HISTORIC AND DESIGN REVIEW COMMISSION

Agenda Item No: 6

HDRC CASE NO: 2016-005
ADDRESS: 224 LAVACA ST
LEGAL DESCRIPTION: NCB 713 BLK 10 LOT E 3.7 OF N 95.1 OF 14, W 9 OF N 91.5 OF 15 & W 45.1 OF E 49.1 OF 15
ZONING: RM4 H
CITY COUNCIL DIST.: 1
DISTRICT: Lavaca Historic District
LANDMARK: Mannewitz / Yznaga House
APPLICANT: Jack Harmon
OWNER: Jack Harmon
TYPE OF WORK: Driveway modification
REQUEST:

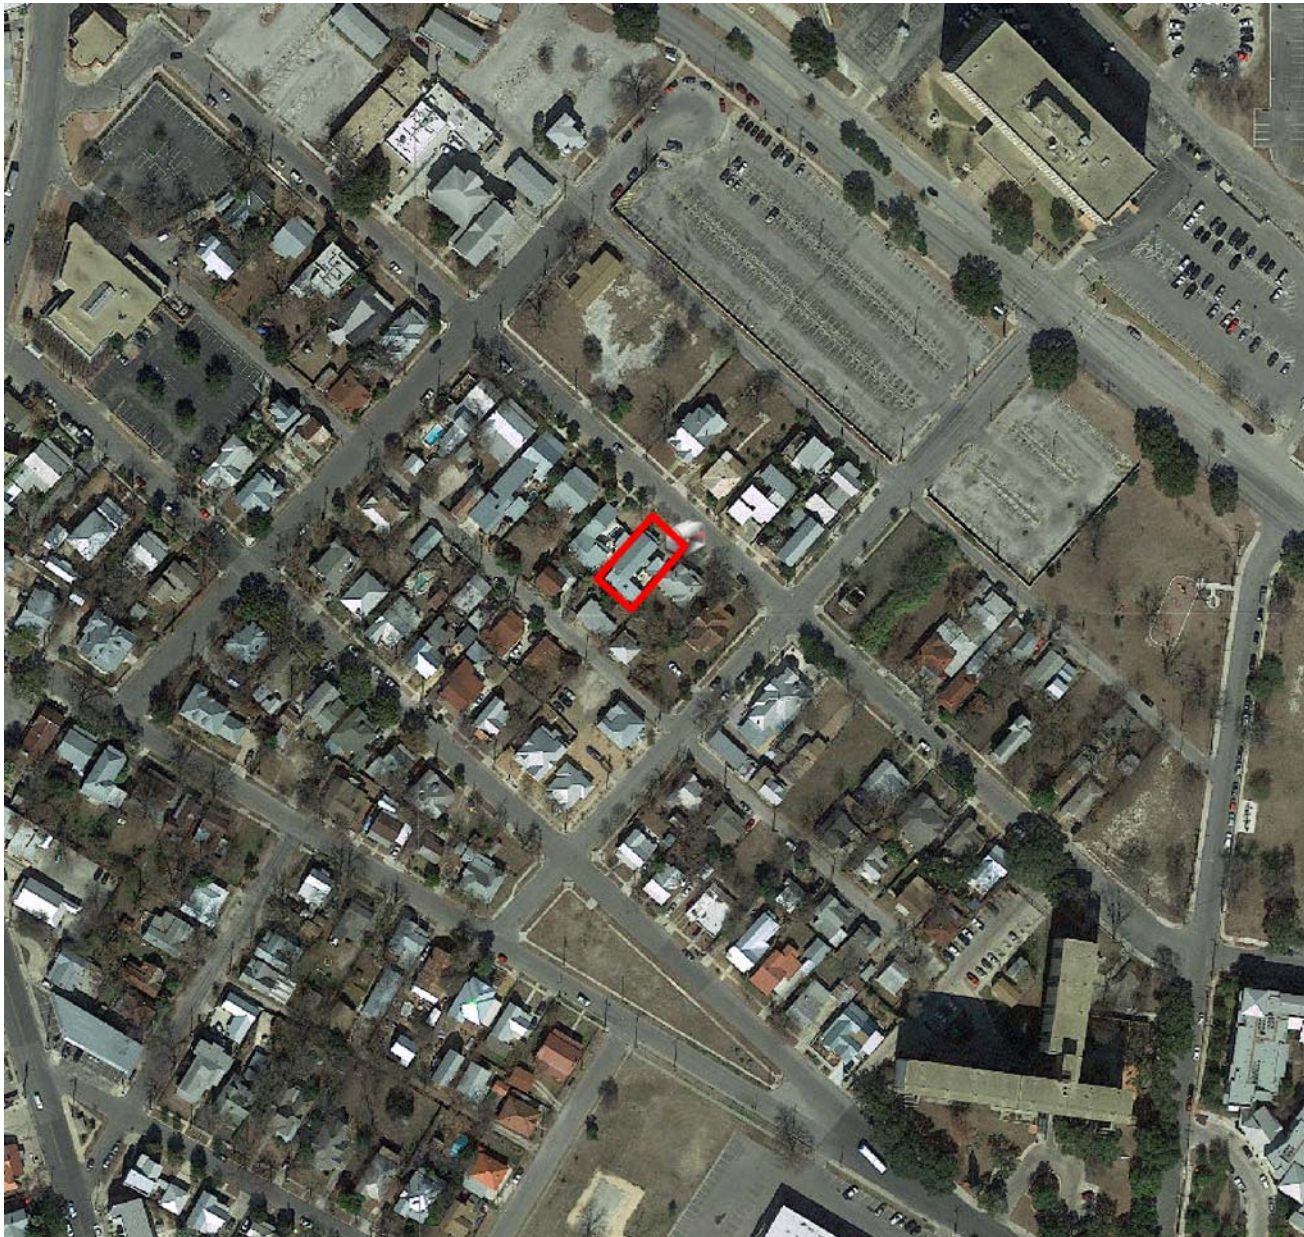
- a. The applicant has proposed to widen the existing driveway approach from being sixteen (16) feet wide at its widest point and twelve (12) feet wide at its narrowest point to be twenty-two (22) feet wide at its widest point and eighteen (18) feet wide at its narrowest point. The property currently features a brick parking surface that is approximately twenty-five (25) feet in width.
- b. According to the Guidelines for Site Elements 5.B.i., historic driveways are typically no wider than ten (10) feet wide. This driveway width is predominant throughout the Lavaca Historic District, however, at this particular property, nontraditional driveway widths, materials and configurations are featured as they are at the properties to the immediate northeast of 224 Lavaca.

Staff finds the applicant's proposal to widen the width existing, nontraditional driveway approach is appropriate and recommends approval as submitted based on findings a and b.
